**Technical Analysis and Findings**  
**Utah Coal Regulatory Program**

**PID:** C0410002  
**TaskID:** 4953  
**Mine Name:** SUFCO MINE  
**Title:** WASTE ROCK SITE EXPANSION

TITLE  
**WASTE ROCK EXPANSION**  
**TASK #4953**

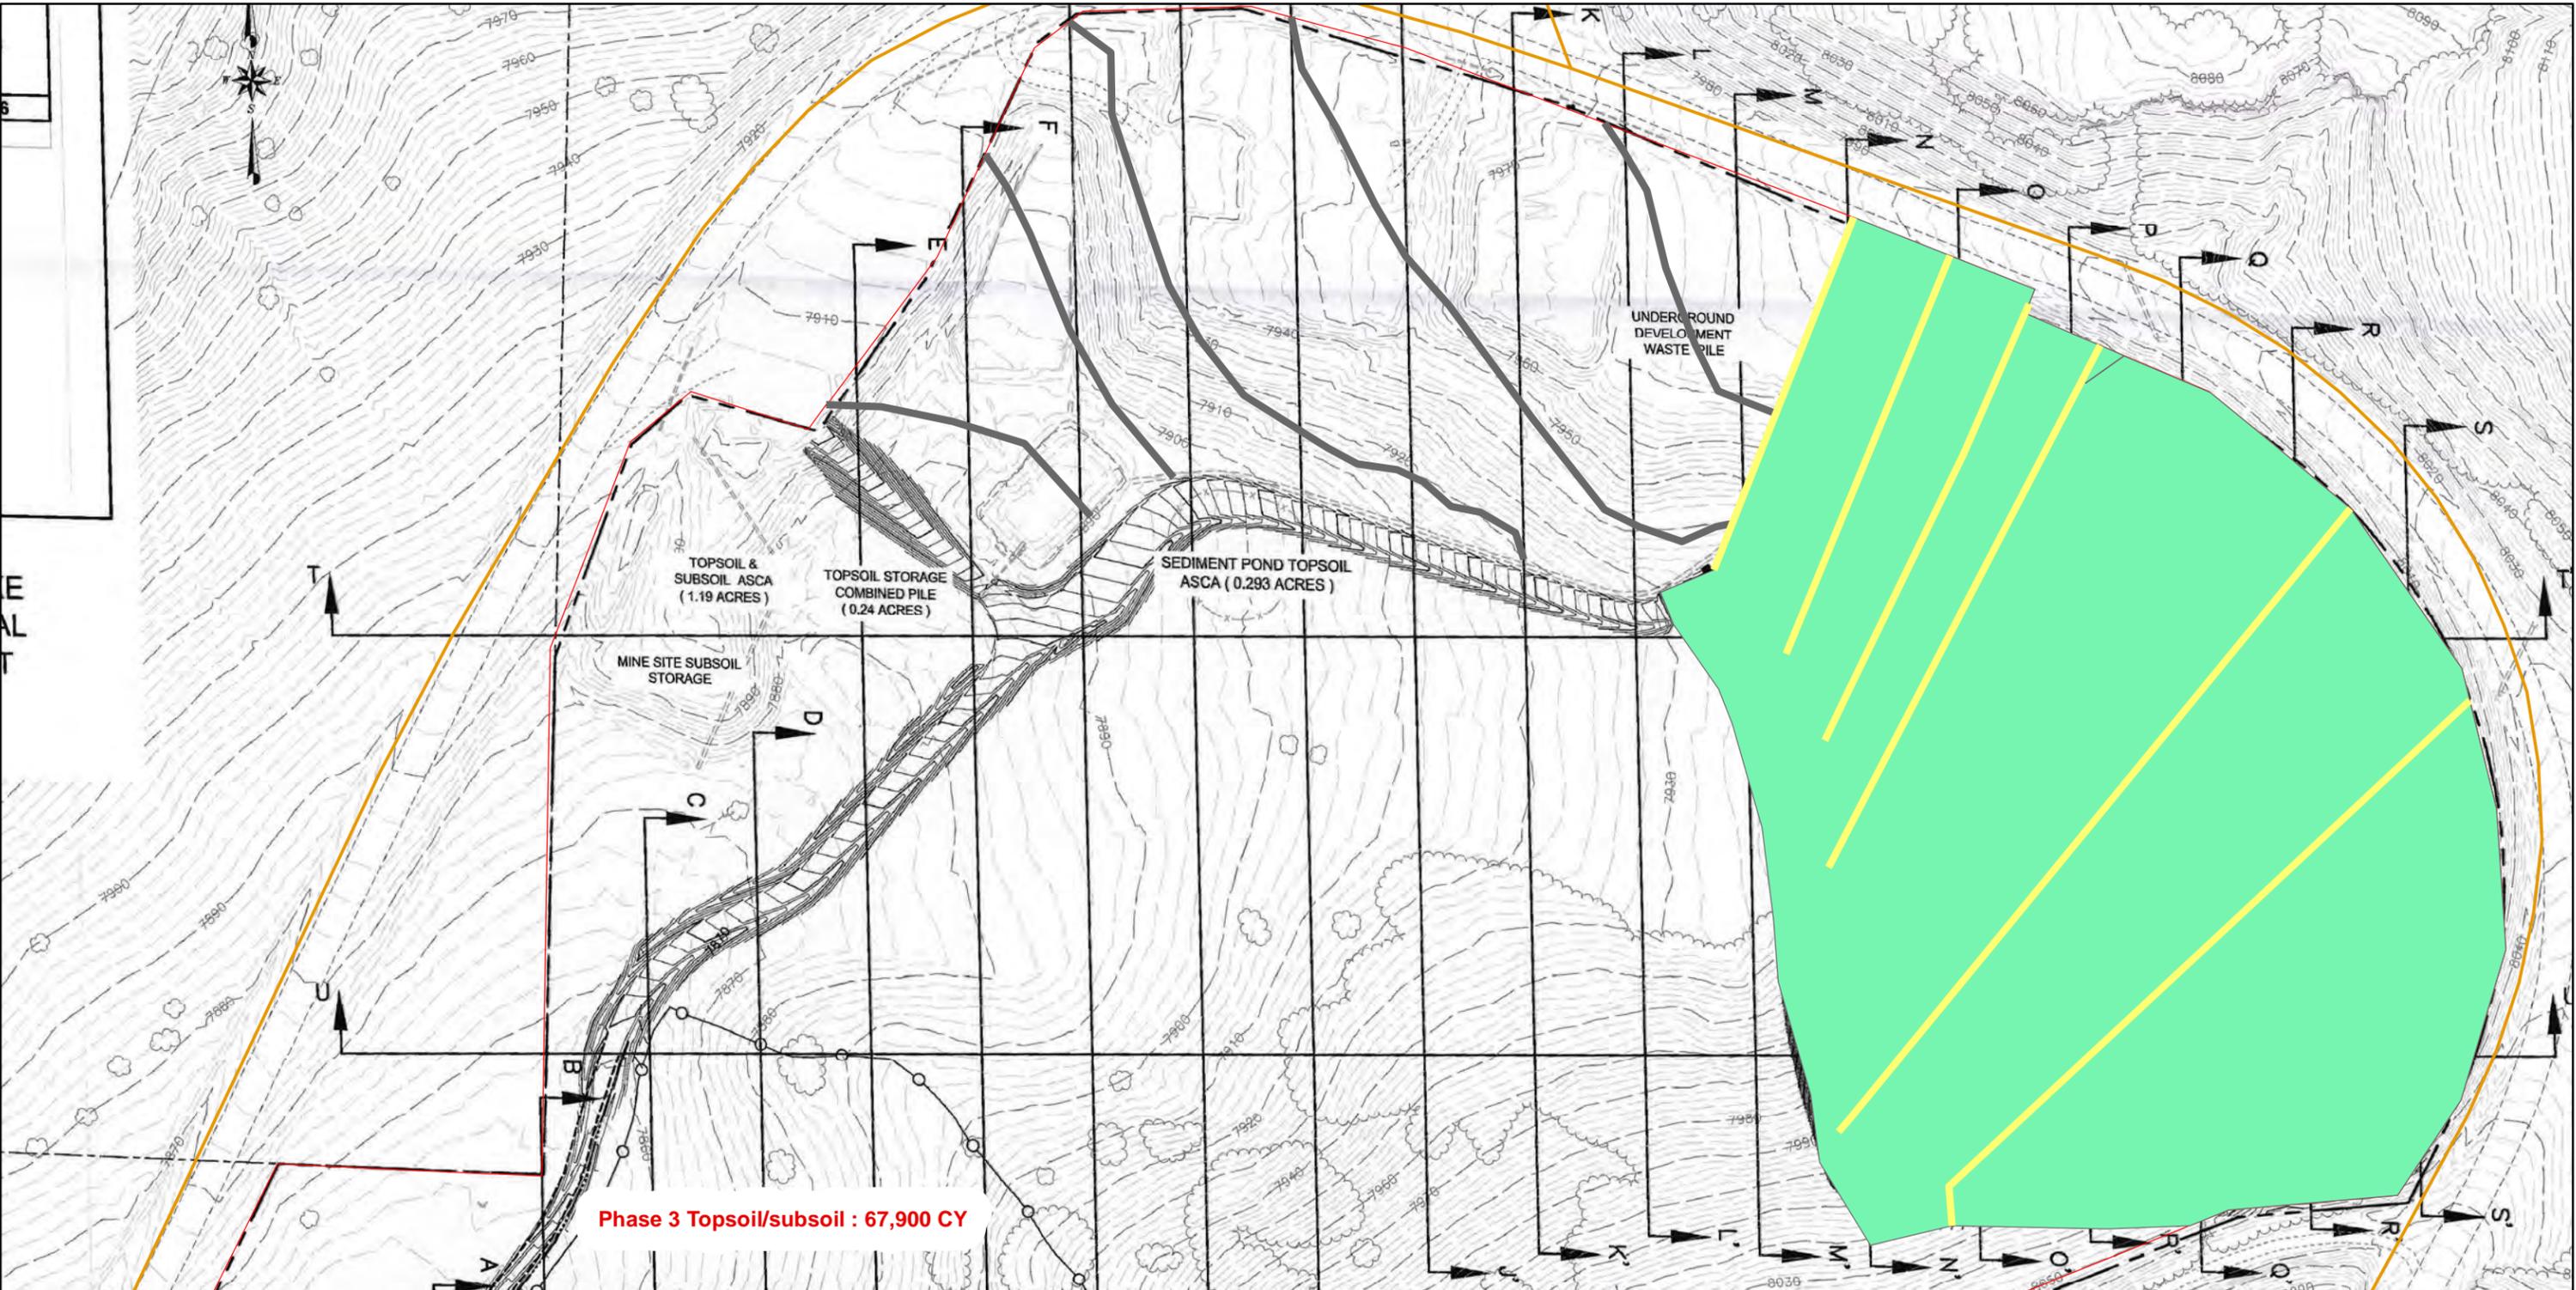
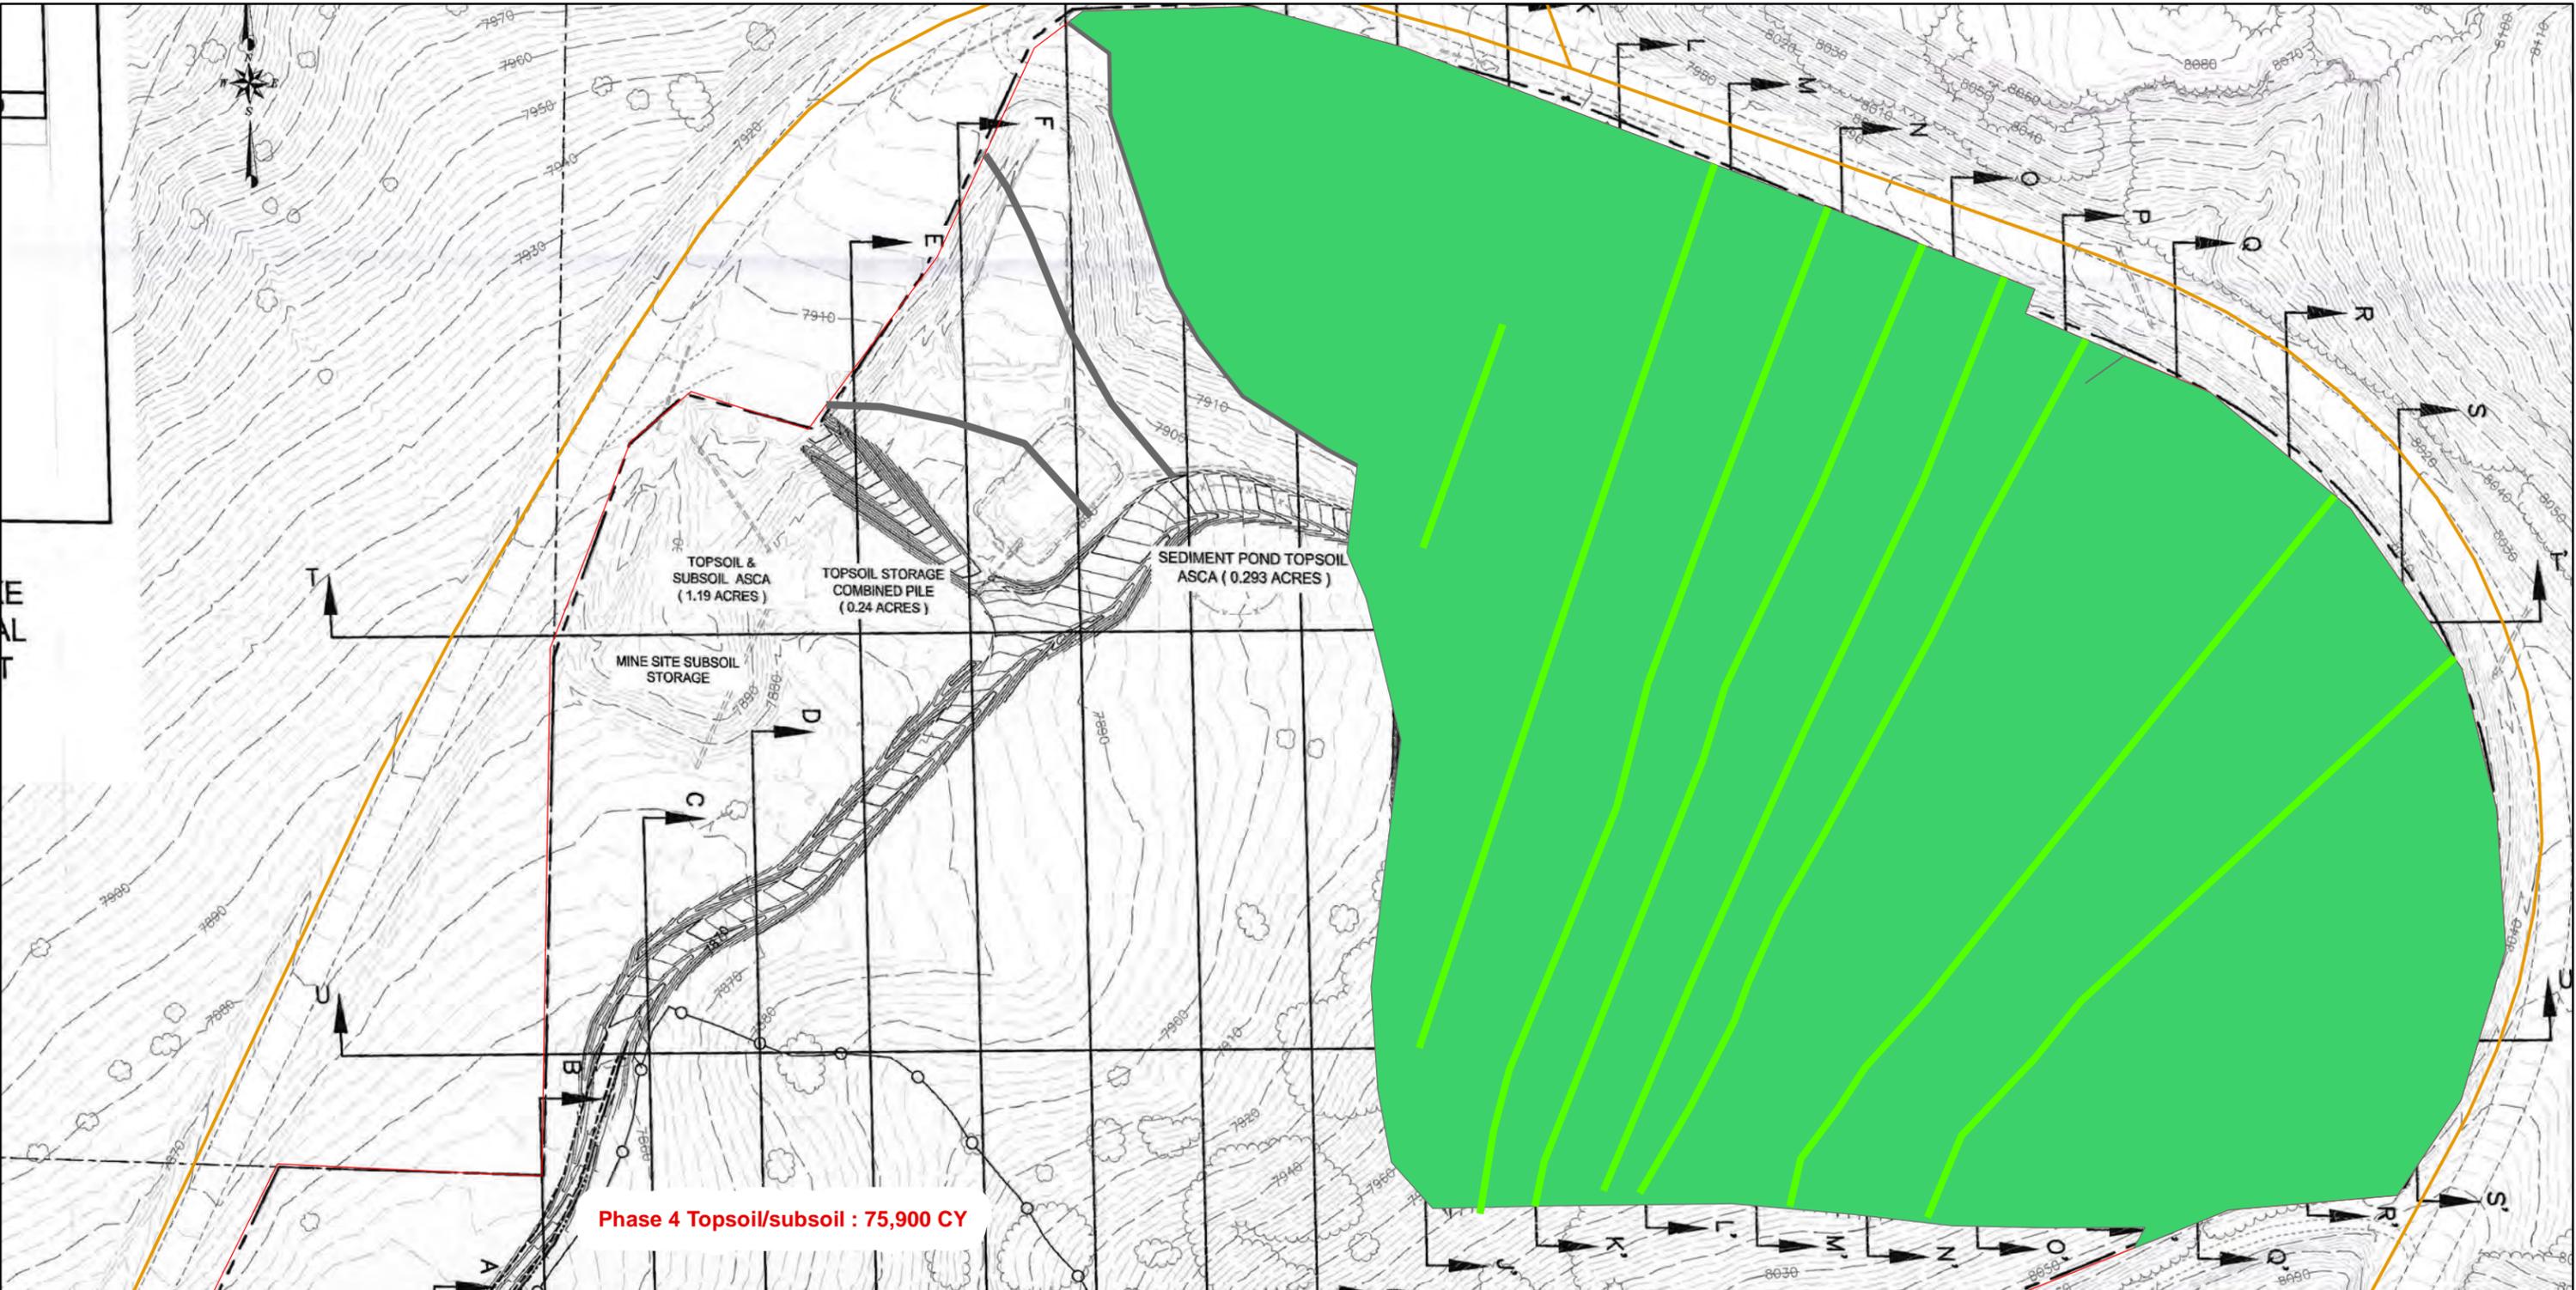
- The application does not detail how the various sequential phases of the waste rock pile will be tied into the existing waste rock pile in the narrative or on Maps 2A through 2E. Maps 2A through 2E, as shown, detail a channel between the existing and proposed waste rock piles as the topography abruptly ends before tying into the corresponding elevation on the existing waste rock pile. Based on the cross section detailed in Map 3A through 3C, the Division believes this is a simple error in the drawings representation of phase areas and the volumes shown on the maps account for the missing void shown on Maps 2A through 2E. The Permittee will amend Maps 2A through 2E to show the proposed operational map tying into existing contours on all sides, as shown on the condensed map on Figure 1 attached.

- Map 4A through 5E shows the approximate footprint area of each phase of the waste rock pile construction, however, they do not detail the area to be worked in the corresponding existing waste rock pile to tie the contours together to achieve a final surface as represented in Map 8. Maps 4A through 5E will be edited to show the complete footprint of where waste rock will be placed including in the proposed waste rock pile and over the existing waste rock pile. See Figure 1 for an approximation of contours.

• The application does not detail how the various sequential phases of the waste rock pile will be tied into the existing waste rock pile in the narrative or on Maps 2A through 2E. Maps 2A through 2E present confusing information as the maps do not show how the proposed waste rock pile will tie into the existing waste rock pile. Maps 2A through 2E, as shown, detail a channel between the existing and proposed waste rock piles as the topography abruptly ends before tying into the corresponding elevation on the existing waste rock pile. Based on the cross section detailed in Map 3A through 3C, the Division believes this is a simple error in the drawings representation of phase areas. The Permittee amend Maps 2A through 2E to show the proposed operational map key into existing contours on all sides.

• Map 4A through 5E shows the approximate footprint area of each phase of the waste rock pile construction, however, the maps do not detail the area to be worked in the corresponding existing waste rock pile to tie the contours together to achieve a final surface as represented in Map 8. Maps 4A through 5E will be edited to show the complete footprint of where waste rock will be placed including in the proposed waste rock pile and over the existing waste rock pile. See Figure 1 for an approximation of contours.
